SEWAGE DISPOSAL SYSTEM

SUBDIVISION Chessie Crossing LOT 24 ROAD 754 Chessie Crossing Way

PROPERTY OWNER Mr. and Mrs. Gillespie

SEPTIC SYSTEM DESIGN DATA:

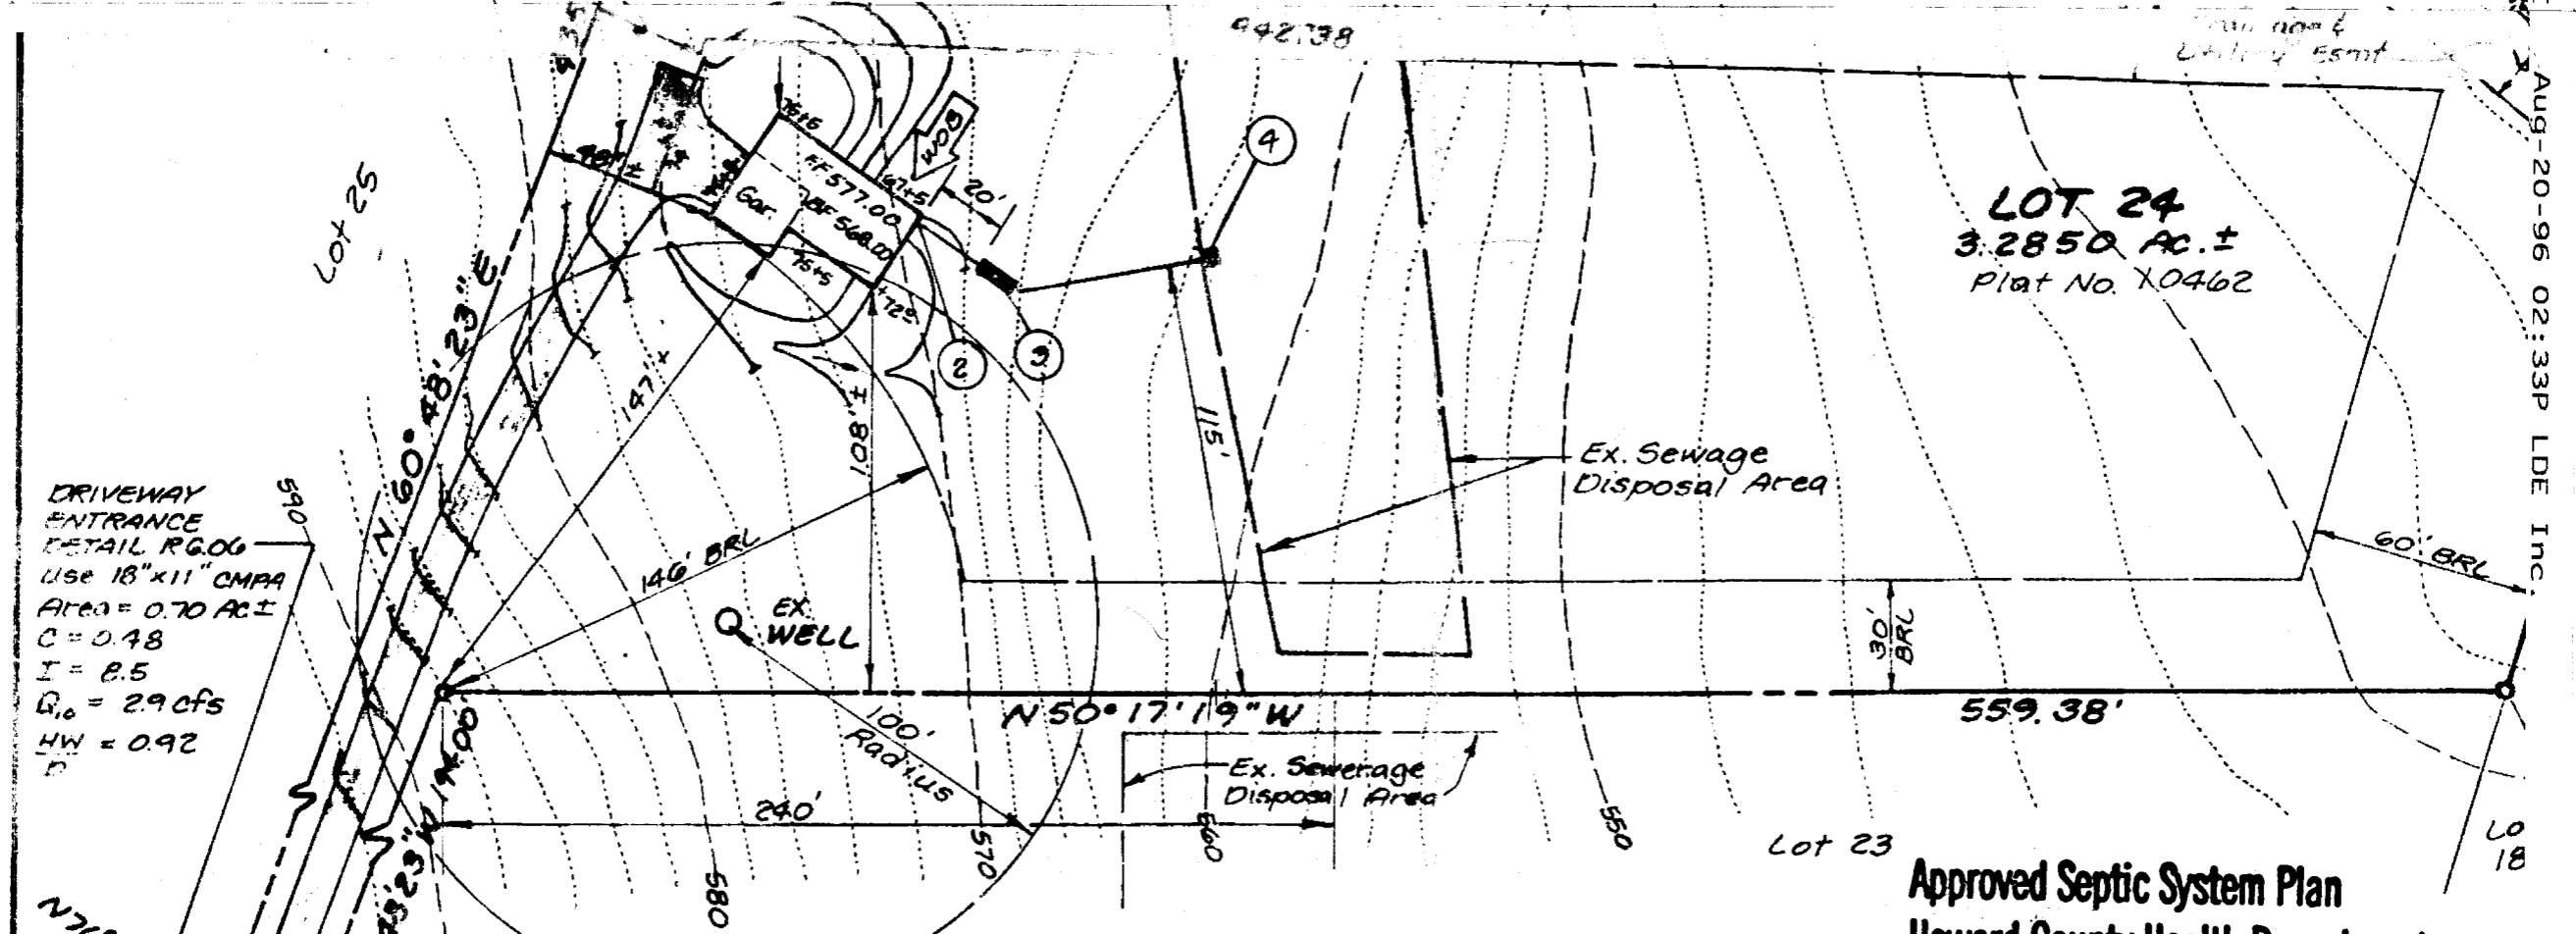
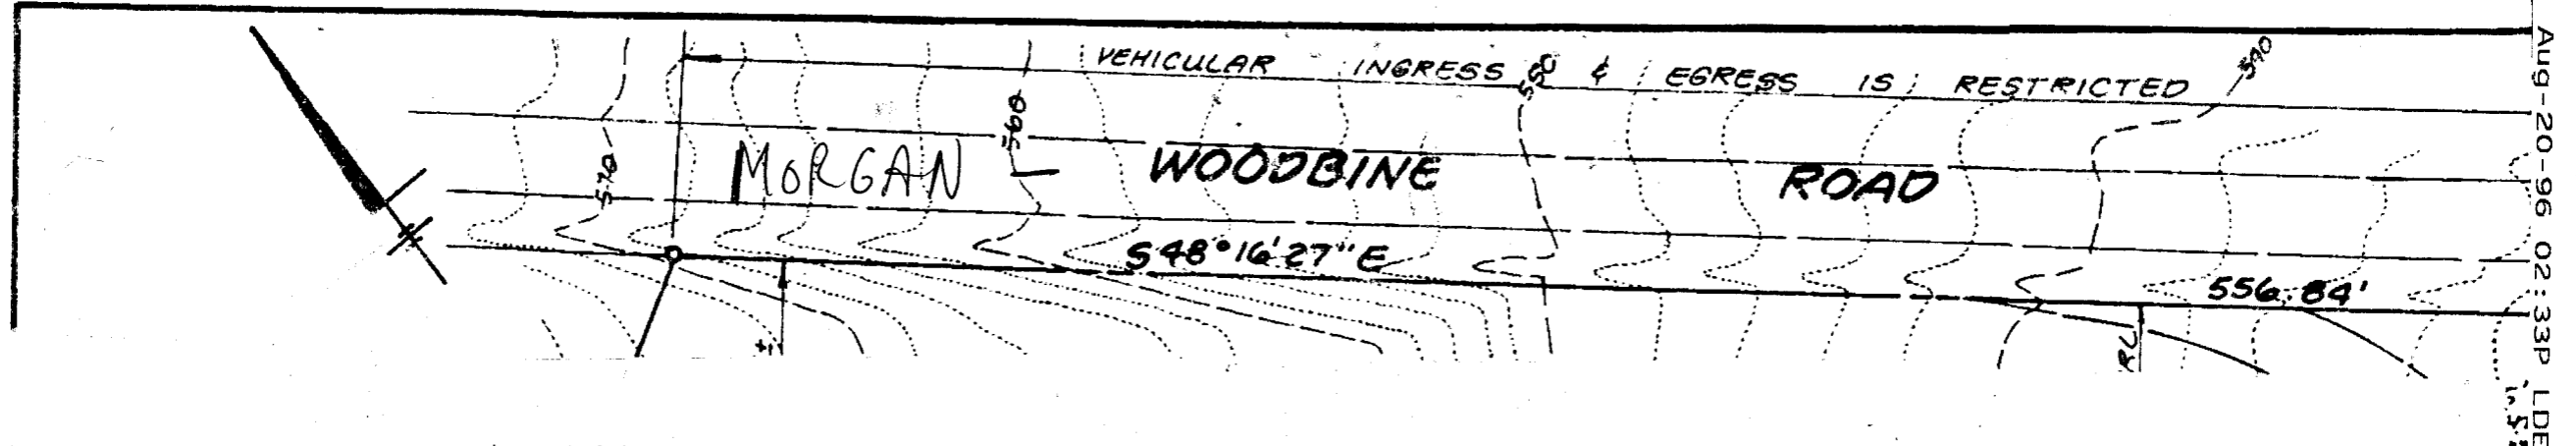
REVISION: OK TO MOVE DIST. BOX 15' HIGHER, INSTALL 2-120' TRENCHES SUGGESTED BY ENGINEER

REMARKS: 11/13/96 OK TO COVER MR
6/12/97 POOL BP REVIEW: HOUSE SITE SHOWN ON HOUSE
PLAN NOT ACCURATE - HOUSE HAS ROTATED MR

SEPTIC TANK LEVEL 1250 - OK CLEANOUTS OK - S.T. & INLINE
 DISTRIBUTION BOX LEVEL OK - BAFFLE IN
 DRAIN FIELD/TITLE DEPTH 4 FT. TRENCH WIDTH 3 FT. INLET DEPTH 2 FT.
 EFFECTIVE GRAVEL DEPTH 2 FT. TOTAL LENGTH 2 @ 120 FT.
 NUMBER OF TRENCHES 2 ONE SIDEWALL/BOTTOM AREA 2 @ 360 SQ. FT.
 DRYWALL INSIDE DIAMETER — FT. EFFECTIVE DEPTH BELOW INLET — FT.
 ABSORBENT AREA 720 SQ. FT.
